Rezoning Application: PD 23-0777

Zoning Hearing Master Date: November 13, 2023

Development Services Department

2.4 Proposed Site Plan (partial provided below for size and orientation purposes. See Section 8.0 for full site plan)

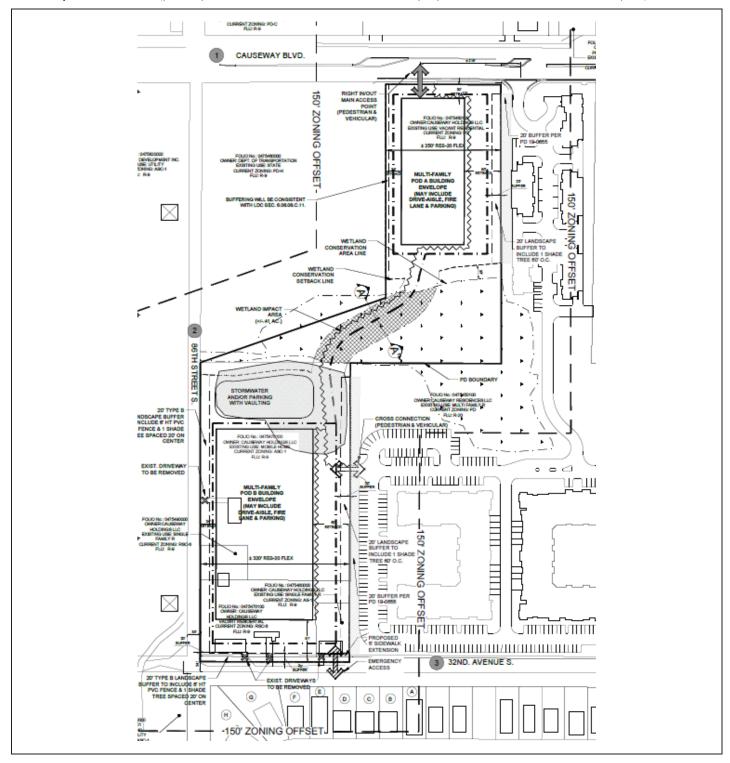
1. Site plan to correct 222 to 221.

3. Add the 100-foot drainage easement to the PD site plan and label "100 Foot-Wide Potential Easement Dedication Area – See Conditions of Approval" in accordance with the requirements of the zoning condition and as general shown in the image to the right, and label "100-Foot Wide Potential Easement Dedication Area – See Conditions of Approval." Modify the label and legend symbology stating "Emergency Access" to instead state "Pedestrian Connection and Gated Emergency Vehicular Access."

- 4. Modify the label and legend symbology stating "Emergency Access" to instead state "Pedestrian Connection and Gated Emergency Vehicular Access".
- 5. Staff notes that sidewalks are inconsistently shown. The applicant shall either add the required sidewalk along the project's 86th St. S frontage or remove the proposed sidewalk along the project's 32nd Ave. S. frontage. Staff notes that regardless of whether such sidewalks are shown, the applicant will be required to construct the required sidewalks internal and external to the project in accordance with LDC Sections 6.02.08 and 6.03.02, and with sufficient separation from the adjacent travel lanes as required pursuant to applicable sections of the LDC and Hillsborough County Transportation Technical Manual.

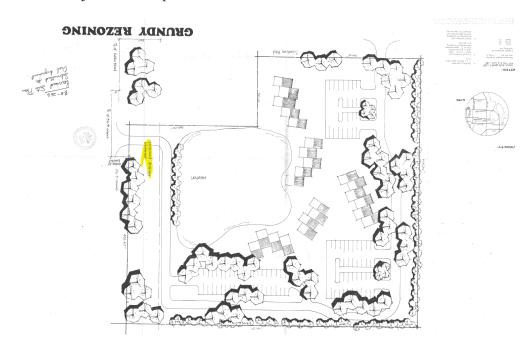
Staff notes the applicant is proposing one (1) pedestrian and gated emergency only access to 32nd Ave S. The applicant is also proposing a vehicular and pedestrian cross access connection to adjacent PD 19-0655, which will connect to stubout which was constructed by that project for future connection upon development/redevelopment of the site which is the subject of this request.

This project will sever the cross connectivity between the adjacent folio and the lands within this project which were a part of PD 85-0262. Such severance is supportable, since the adjacent project is being simultaneously modified to remove residential entitlements from that PD (and so no shared access or interconnectivity will be necessary given that adjacent PD will only permit stormwater pond uses after the 24-0110 modification is complete).
